MCRAE PLACE SUBDIVISION

APPLICATION NUMBER 22 DATE April 7, 2005

APPLICANT McRae Subdivision

DETAIL SITE PLAN

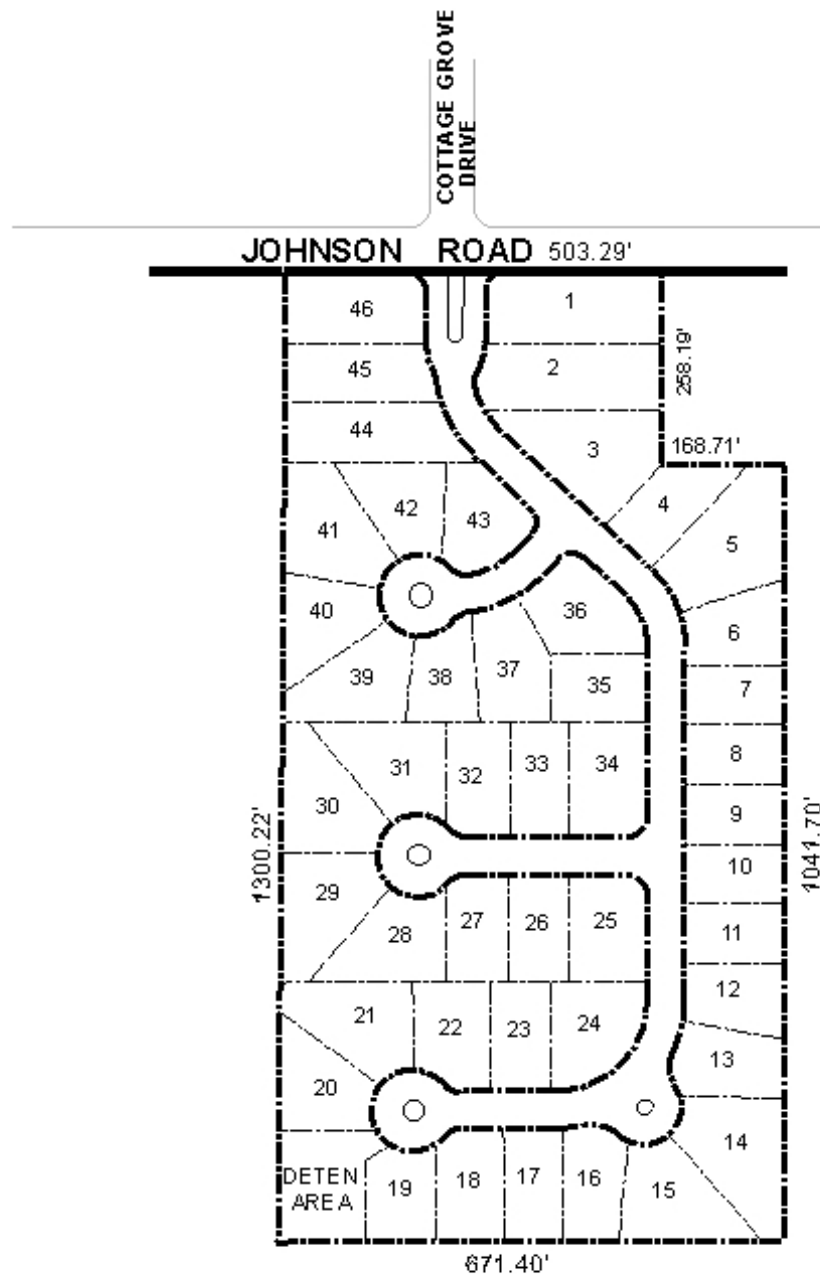
The site fronts Johnson Road, which has an existing 60' right-of-way. As a means of access management, a note should be placed on the final plat stating that Lots 1 and 46 are denied direct access to Johnson Road.

The subdivision involves the creation of new streets; all new streets should be constructed to County Engineering standards and dedicated. As the site abuts large undeveloped parcels to the East and South, street stubs to the East and South should be required. Furthermore, there is a subdivision to the West (Spring Brook), of which only two units have been recorded. However, a condition of approval for Spring Brook required a street stub East; thus a street stub connecting to the Spring Brook stub should be required.

The required 25' building setback lines are not shown but would be required on the final plat. Additionally, the islands within the roadways should be labeled as common areas, and a note should be placed on the final plat stating that the maintenance of the common areas and detention area shall be the responsibility of the property owners.

With modifications, the plat will meet the requirements of the Subdivision Regulations, and is recommended for Tentative Approval, subject to the following conditions: 1) the placement of a note on the final plat stating that Lots 1 and 46 are denied direct access to Johnson Road; 2) the provision of street stubs to the East and South, and a street stub to the West to connect with Spring Brook; 3) the construction and dedication of the new streets; 4) the depiction of the 25' building setback lines on the final plat; 5) that all islands within the roadways be labeled as common areas; 6) the placement of a note stating that maintenance of common areas and the detention area shall be the responsibility of the property owners; and 7) the placement of a note on the final plat stating that any lots that are developed commercially and adjoin residentially developed property must provide a buffer, in compliance with Section V.A.7 of the Subdivision Regulations.
